HISTORIC PRESERVATION PERMIT

An Historic Preservation Permit for work described below has been issued under the Zoning Ordinance of the City of Tulsa (Section 70.070) to **Olson & Associates Properties, LLC**, for the address of **1546 South Yorktown Place**, Tulsa, Oklahoma, located in the **Gillette Historic Preservation Overlay District**. This proposal has been approved by the Tulsa Preservation Commission.

APPROVED PROPOSAL

Number: HP-0389-2022

④ NEW East Elevation @ Porch
Scale: 1/4" = 1'-0"

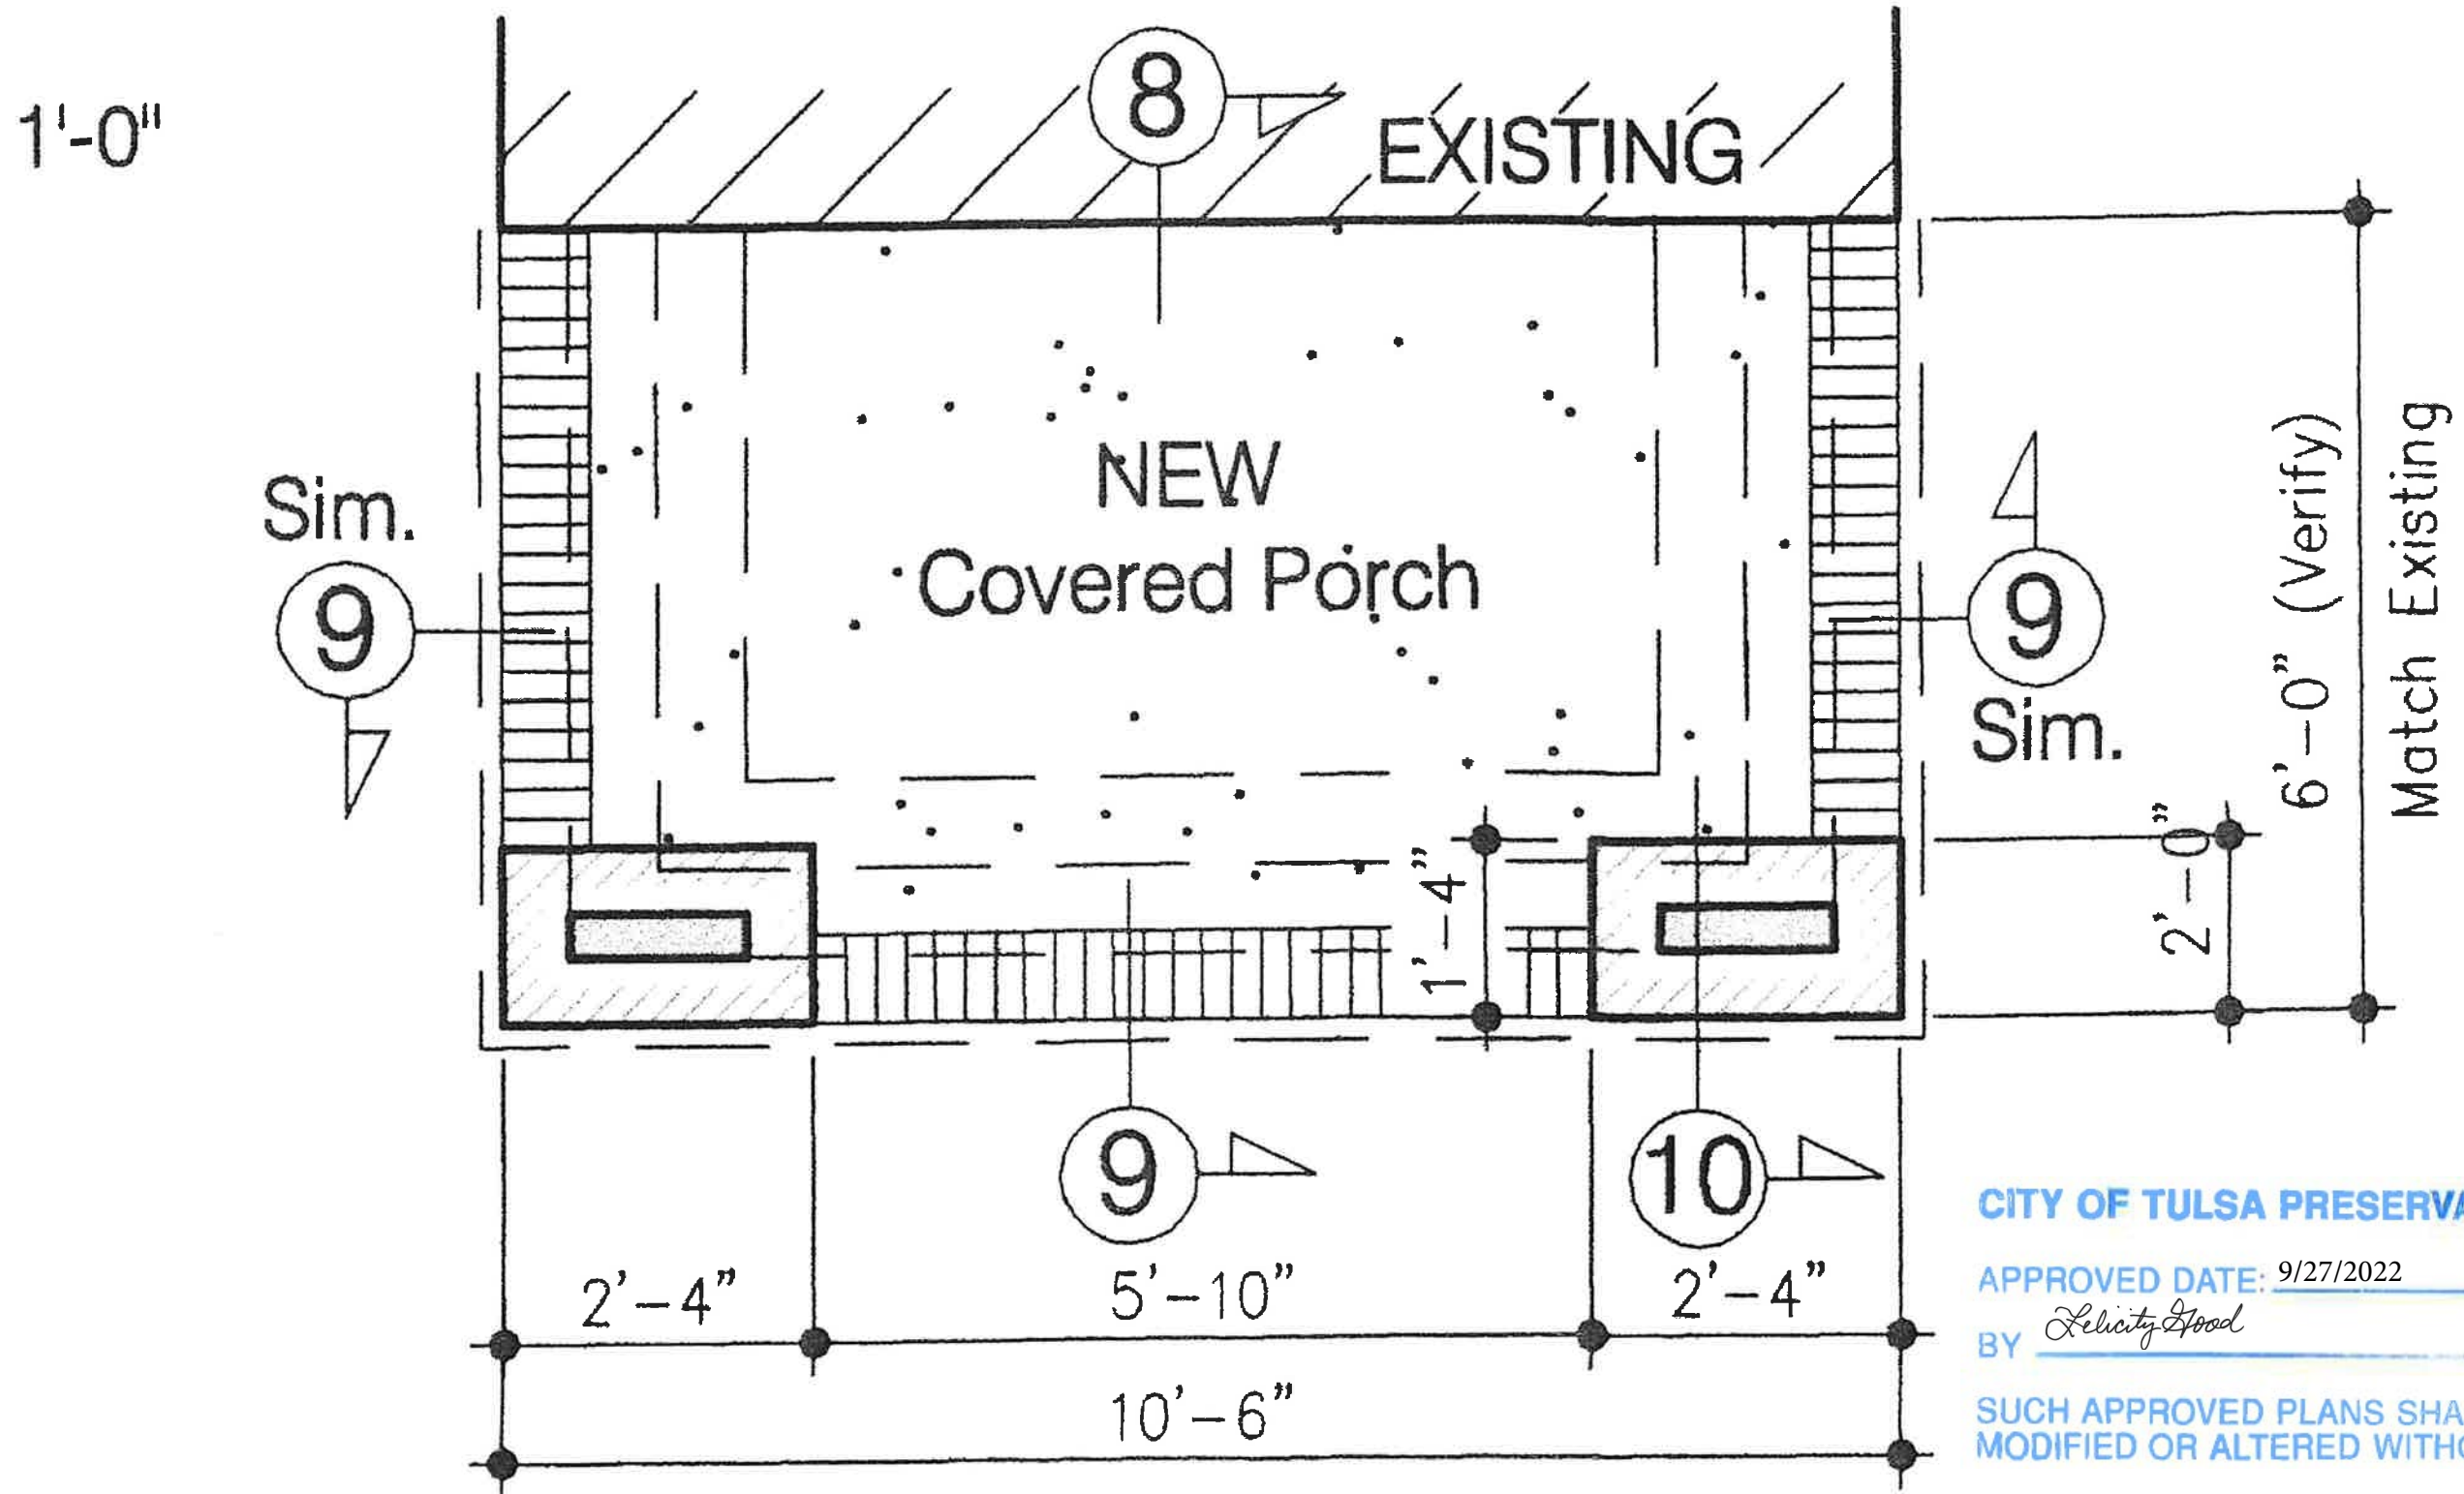
Construction of porch on east side of residence with the conditions that

- the roof line match the existing gable roof
- the trim match the existing trim
- the opening in the gable contain no window
- the porch floor be replaced with similarly tinted concrete in a matching pattern as the existing
- bricks from the rear of the garage be reused for the entire porch addition
- the mortar match the existing mortar
- the house number be moved to or replicated in the new gable
